Access Compliance Report

Public Rights-of-Way

(Curb Ramps)

Intersection ID: 49297	Main Street: CAMPBELL_HALL_CT	Cross Street: CHAMBERLIN_RD	Location: SW
ADA ID: CF559E4C7B89	Ramp Type: Perp	Initial Pass/Fail: Fail	Overall Compliance: No
Severity Score: 1.25			
Codes/Mitigation Info/Possible Solution		Field Measurements/Component Compliance

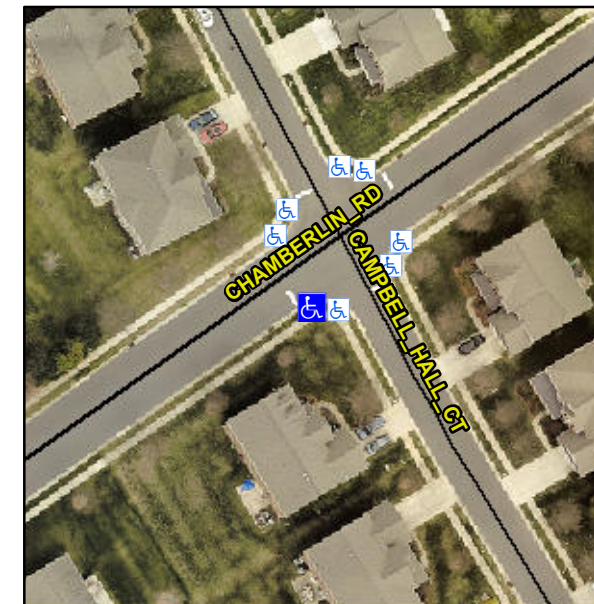
Not Found, R304.5.3

Compliance	Description	Data	Compliance	Description	Data
N/A	Ramp Length (in)	48.0	Yes	Ramp Slope (%)	5.6
Yes	Ramp Width (in)	48.0	No	Ramp XSlope (%)	2.8
N/A	Flare Type LT	N/A	N/A	Flare Type RT	N/A
N/A	Flare Slope LT (%)	N/A	N/A	Flare Slope RT (%)	N/A
N/A	Flare Traversable LT?	N/A	N/A	Flare Traversable RT?	N/A
N/A	Landing Length (in)	N/A	N/A	DWS Provided?	N/A
N/A	Landing Width (in)	N/A	N/A	DWS Contrast?	N/A
N/A	Landing Slope (%)	N/A	N/A	DWS Length (in)	N/A
N/A	Landing X Slope (%)	N/A	N/A	DWS Full Width?	N/A
N/A	Landing Curb? (Y/N)	N/A	N/A	DWS Offset (in)	N/A
N/A	Shared Landing?	N/A			
N/A	Gutter Ponding?	N/A	N/A	Gutter Slope (%)	N/A
N/A	Gutter Lip Ht (in)	N/A	N/A	Gutter X Slope (%)	N/A
N/A	Painted X Walk1?	No	N/A	Painted X Walk2?	N/A
	X Walk 1 Direction	To NW		X Walk 2 Direction	N/A
N/A	X Walk 1 Width (in)	N/A	N/A	X Walk 2 Width (in)	N/A
	X Walk 1 Slope (%)	3.1		X Walk 2 Slope (%)	N/A
	X Walk 1 X Slope (%)	1.5		X Walk 2 X Slope (%)	N/A

Remove & Replace Entire Ramp.
